# CITY OF ALBUQUERQUE

**RE: McMahon Market Place – Lot 9B  
1440 Coors Blvd. NW  
Grading and Drainage Plan  
Engineer's Stamp Date: 09/12/22  
Hydrology File: A11D011I**

Based upon the information provided in your submittal received 10/31/2022, the Grading & Drainage Plan is approved for Building Permit. Please attach a copy of this approved plan in the construction sets for Building Permit processing along with a copy of this letter.

GRADING & DRAINAGE PLAN  
SCALE: 1" = 20'

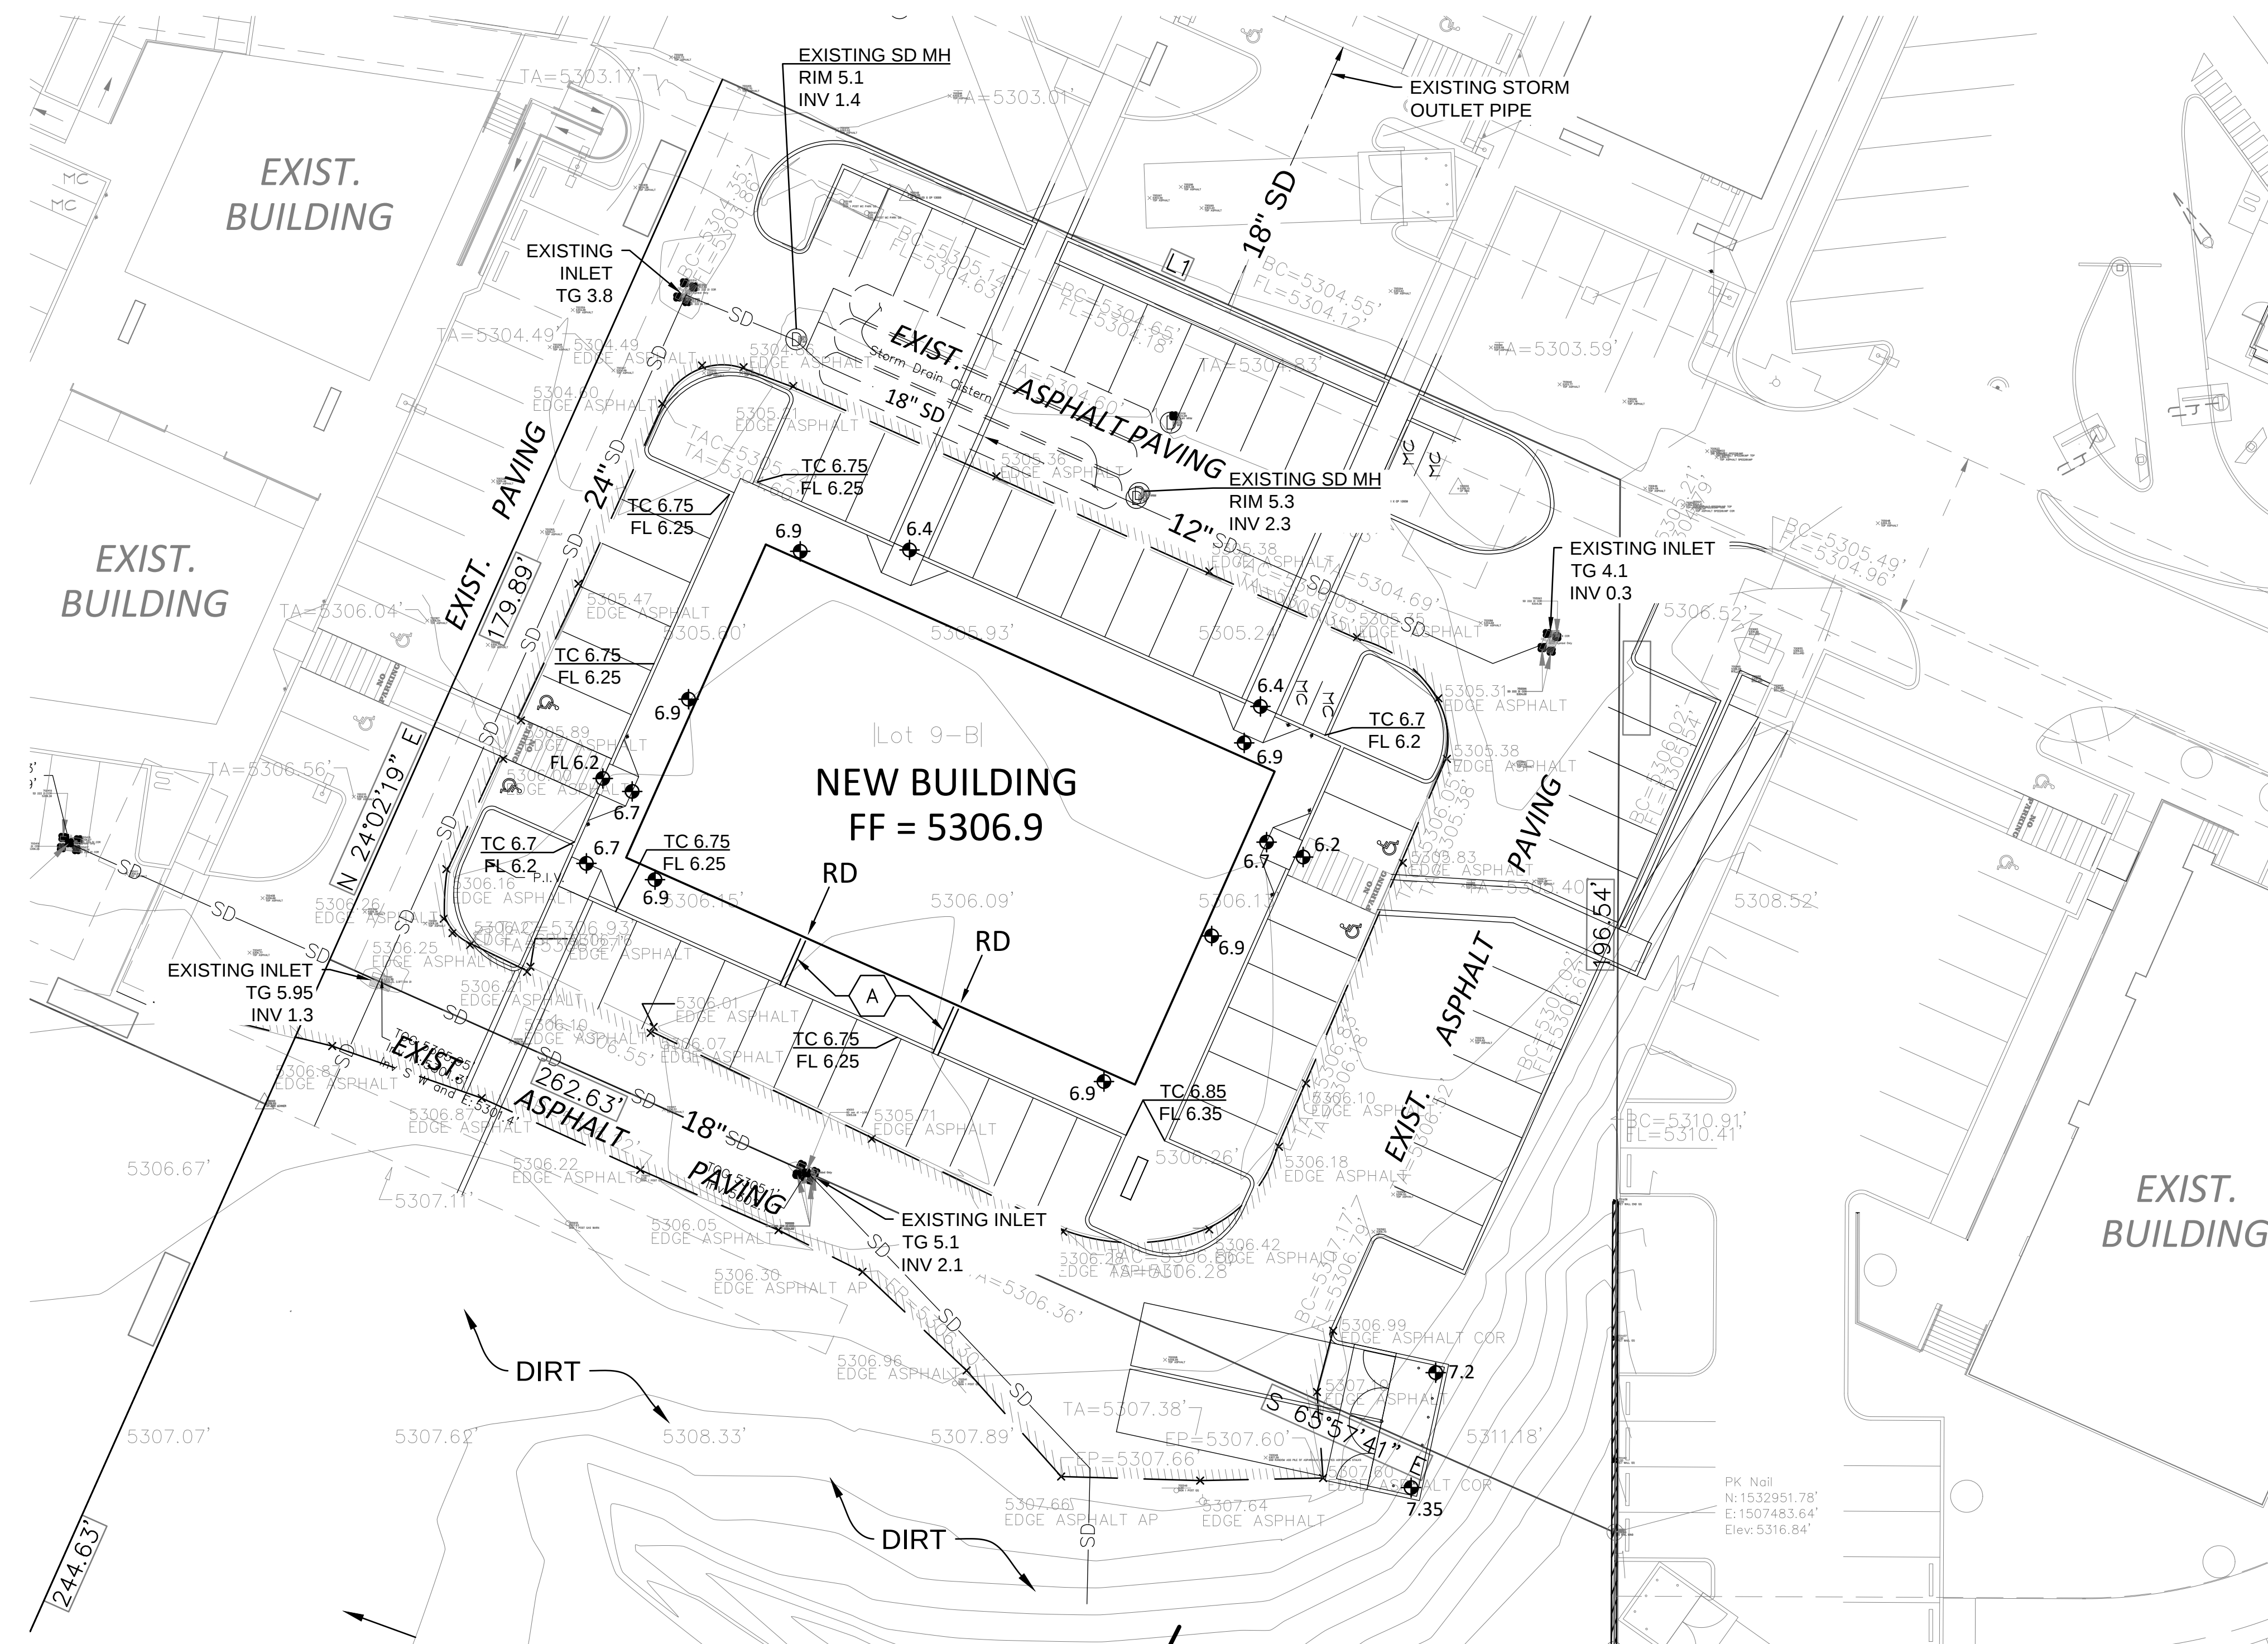
1. Engineer's Certification, per the DPM Part 6-14 (F): *Engineer's Certification Checklist For Non-Subdivision* is required.
